Re: Docket No. 50-275-OL
Docket No. 50-323-OL
Diablo Canyon Units 1 and 2

REPLY TO NRC LETTER OF JUNE 1, 1977
CONCERNING ANALYSIS OF POSTULATED MAIN STEAM LINE BREAK ACCIDENT

Figure Q 6.44 – 1

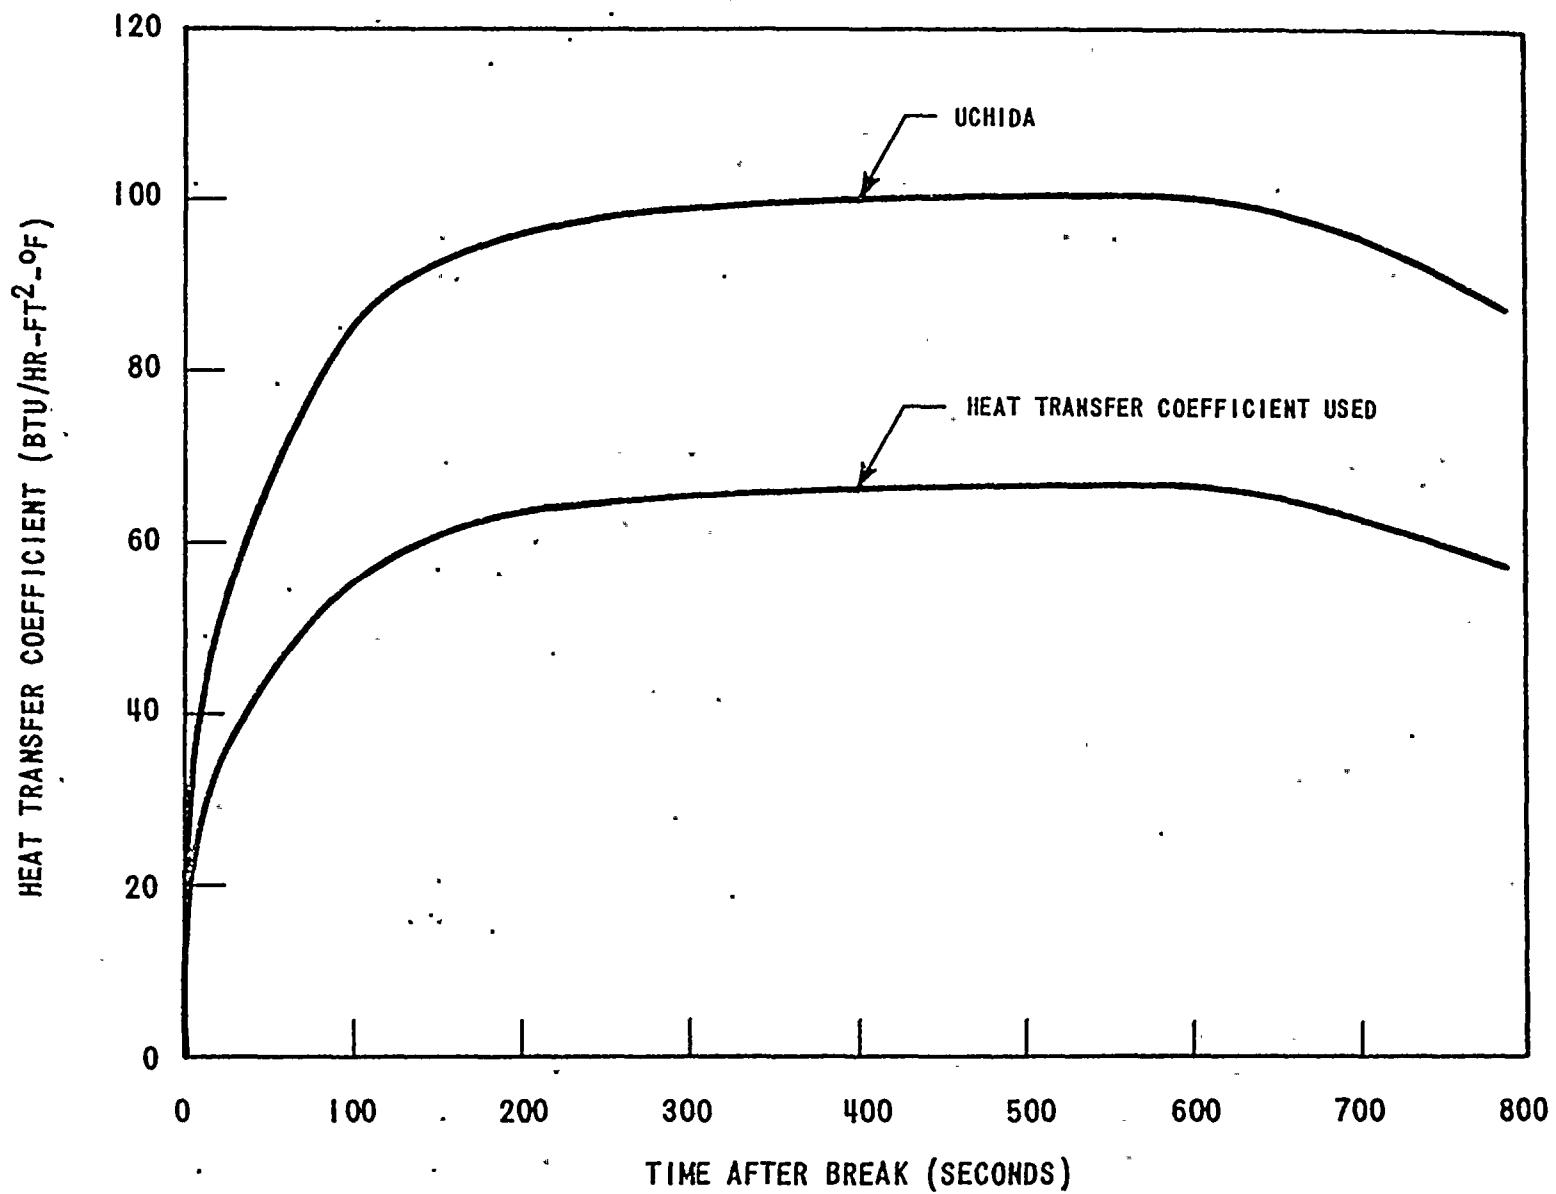
- B. Q. Discuss and justify the assumptions made regarding the time at which active containment heat removal systems become effective.
 - A. The active containment heat removal systems in the Diablo Canyon Nuclear Power Plant are the spray system and fan cooler system. The sprays and fan coolers are assumed to start 40 seconds after the containment transient begins.
 - C. Q. Discuss and justify the heat transfer correlation(s) (e.g., Tagami, Uchida) used to calculate the heat transfer from the containment atmosphere to the passive heat sinks, and provide a plot of the heat transfer coefficient versus time for the most severe steam line break accident analyzed.

- A. A plot of the heat transfer coefficient versus time for the worst break (1.4 ft² break with a failed steam line check valve) is given in Figure Q6.44-1. These heat transfer coefficients are based upon the work of Tagami (Reference 1). Figure Q6.44-1 compares the stagnant Tagami correlations (used for this analysis) with the Uchida correlation's heat transfer coefficients. This comparison illustrates the conservatism of the Tagami coefficients used.

Figure Q 6.44 – 2

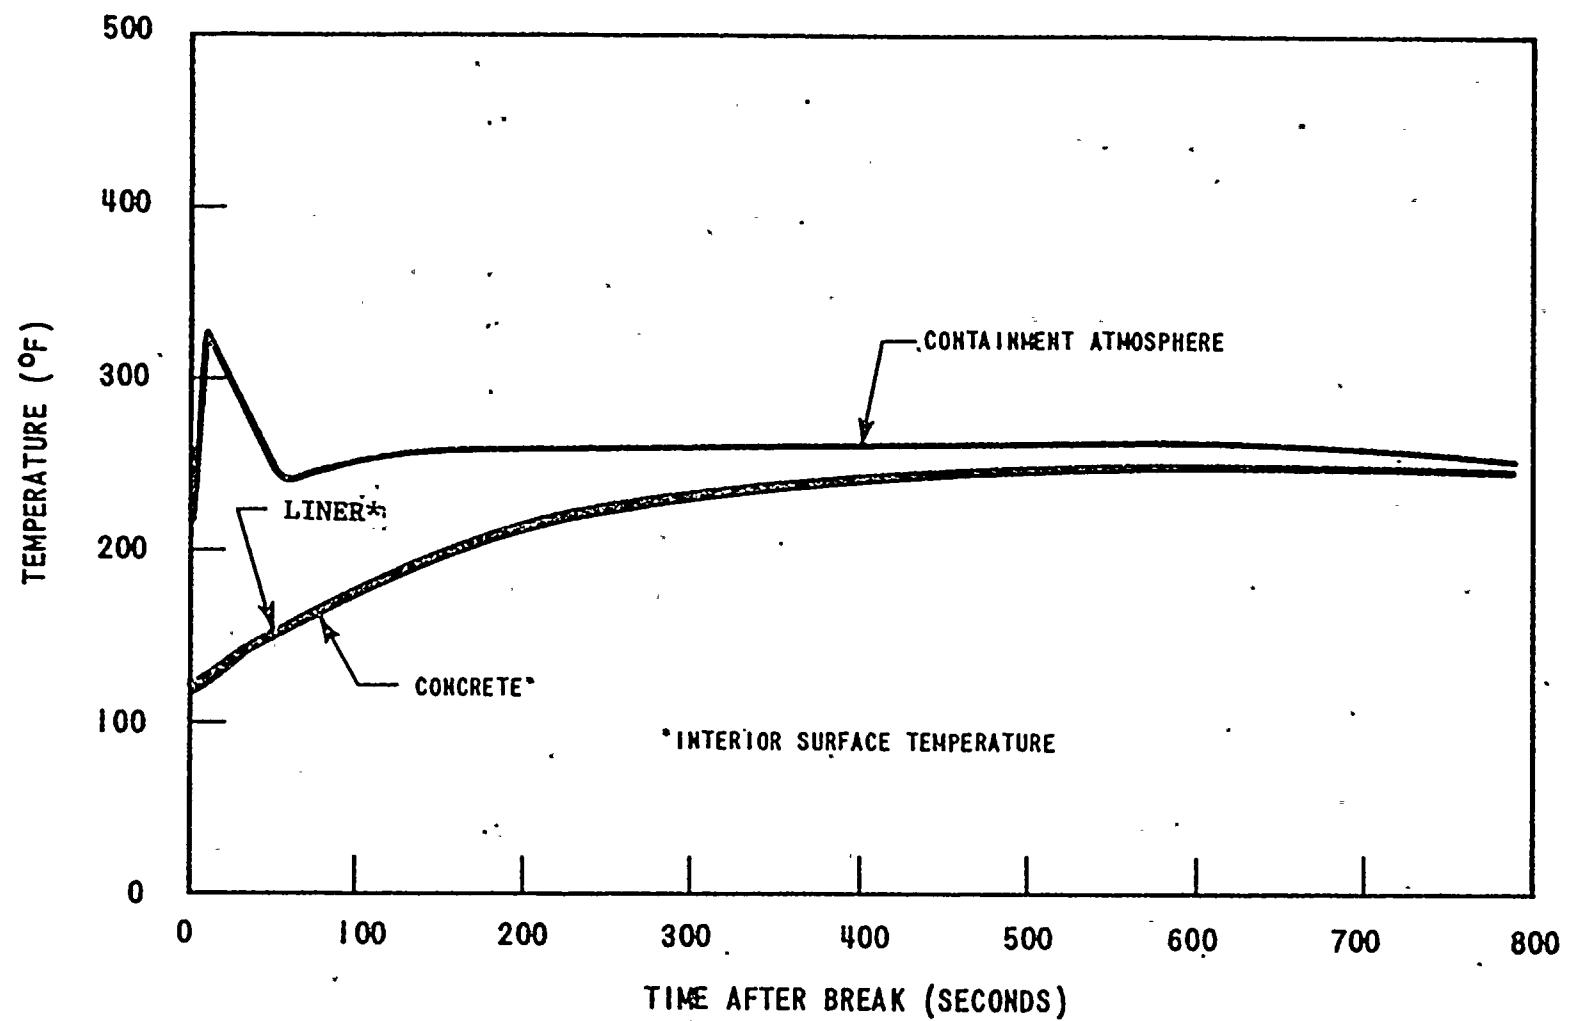
- A. Table Q6.44-1 provides a table of peak pressures for all breaks analyzed. Table Q6.44-2 provides peak temperatures for these breaks.
- G. Q. For the case which results in the maximum containment atmosphere temperature, graphically show the containment atmosphere temperature, the containment liner temperature, and the containment concrete temperature as a function of time. Compare the calculated containment atmosphere temperature response to the temperature profile used in the environmental qualification program for those safety related instruments and mechanical components needed to mitigate the consequences of the assumed main steam line break and effect safety reactor shutdown.

- A. Figure Q6.44-2 shows the containment atmosphere, liner, and concrete temperatures versus time for the worst case steam break.

A comparison of Diablo Canyon containment atmosphere response to the environmental qualification profile for transmitters shows that at about 10 seconds the containment temperature reaches 326°F which is 6°F above the envelope at that time. This peak exceeds the transmitter qualification envelope for a brief period of time (20 seconds), is a superheated condition (containment pressure is 22 psig), and occurs early in the transient. The instrument tests reported in Reference 5 demonstrate that this peak will not result in the equipment's temperature exceeding the qualification temperature. Comparing the containment atmosphere response to the qualification temperature profile for the Fan Cooler Motor (with Heat Exchanger) shows the containment response is 2°F above the peak temperature reached in the Fan Cooler Motor (with Heat Exchanger) test (324°F, 70 psig). However, for the same reasons as above, the peak will not result in the equipment's temperature exceeding the qualification temperature.

Figure Q 6.44 – 3

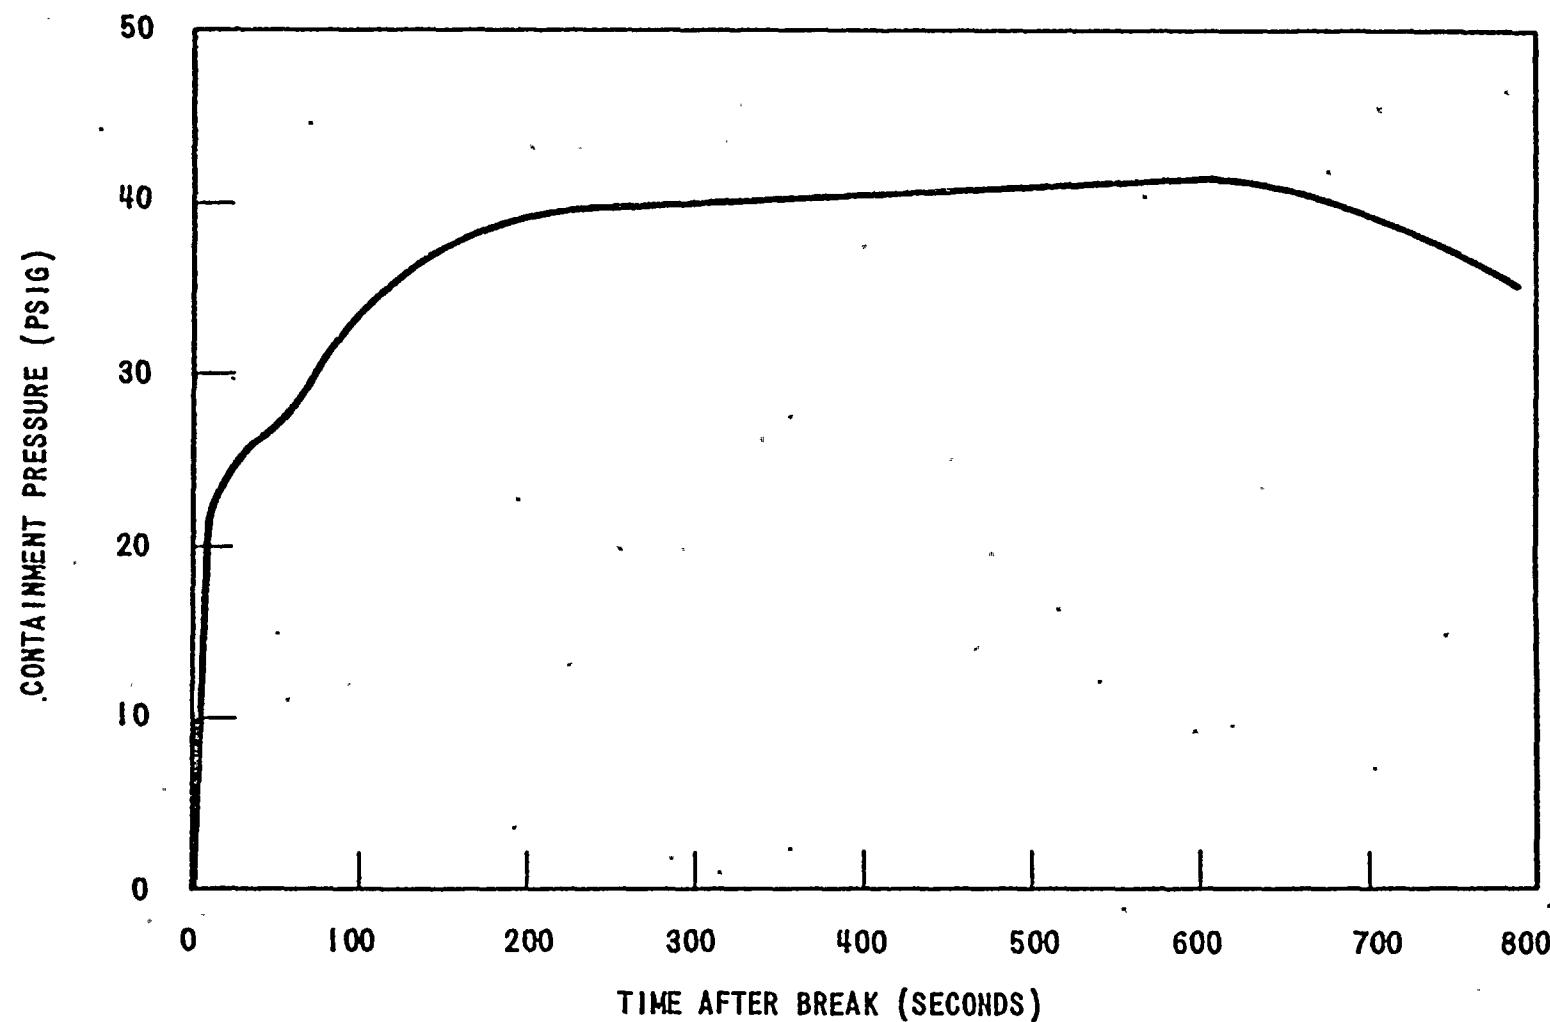
- H. Q. For the case which results in maximum containment atmosphere pressure, graphically show the containment pressure as a function of time.
- A. Figure Q6.44-3 shows the containment pressure versus time for the worst break.
